Proposed Rear Elevation
AMENDMENTS - ANNOTATED IN GREEN

17/01/24 Planning Amendment SG MS -

Project	126 HIGH STREET, HURSTPIERPOINT, HASSOCKS, WEST SUSSEX, BN6 9PX			Project No.	014
Client	PRIVATE				
Scale Format	1:50@A1, 1:100@A3	Drawn By	SG	Revision	
Issue	Planning	Checked By	MS		-

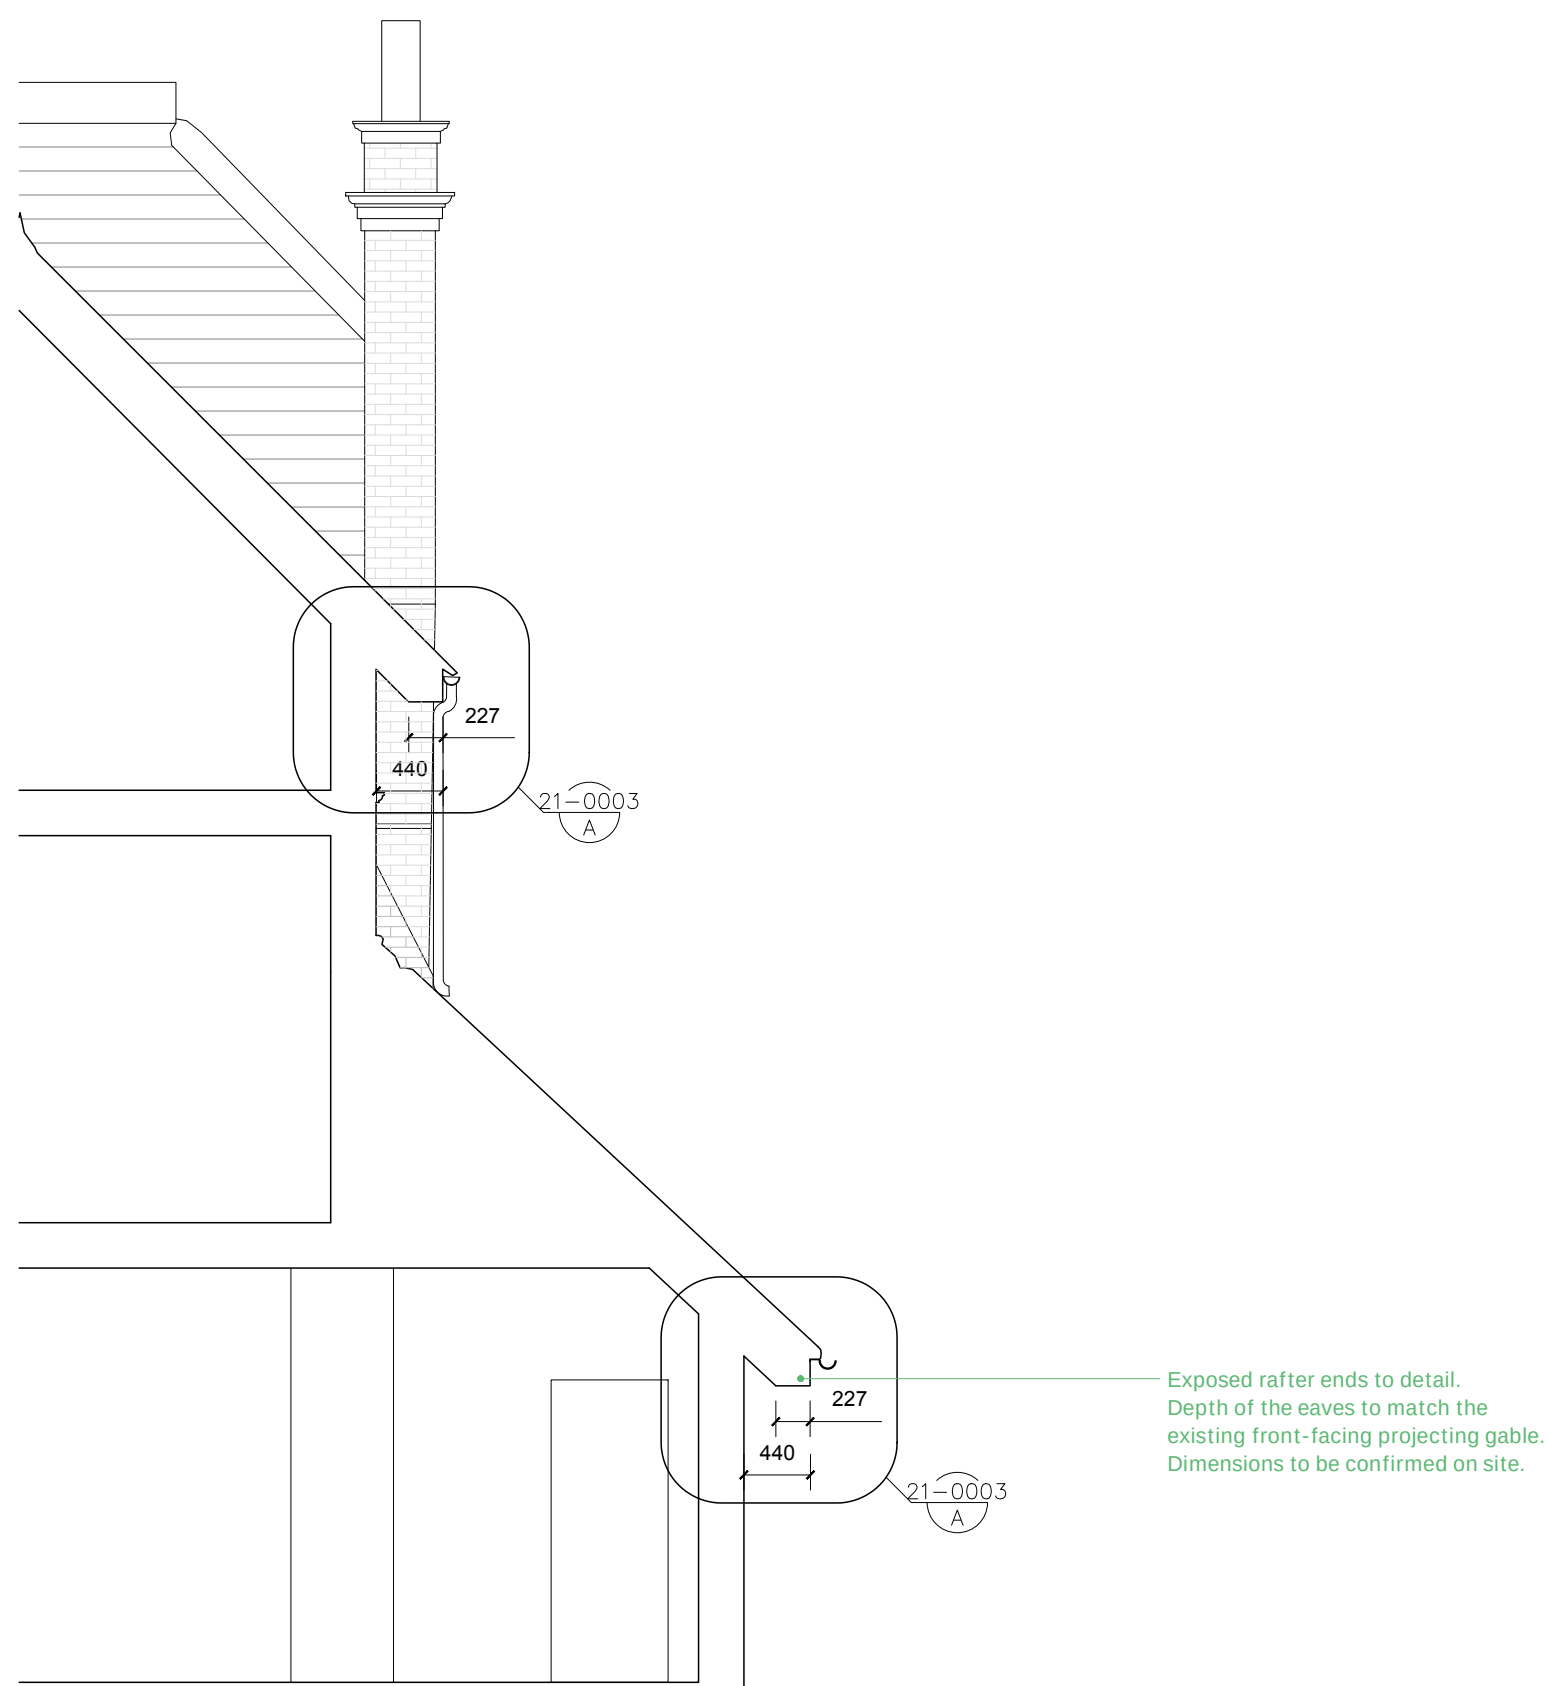
NOTE
The design was initially prepared by Rdjw Architects Ltd. For detailed information, please consult Rdjw Architects Dwg 6171-013-REV A.
Mark Stevens Architects Ltd has been tasked with implementing modifications to the scheme in response to comments from the Planning officer.
Any alterations made will be clearly indicated in green annotations. In the absence of such annotations, no changes are proposed.
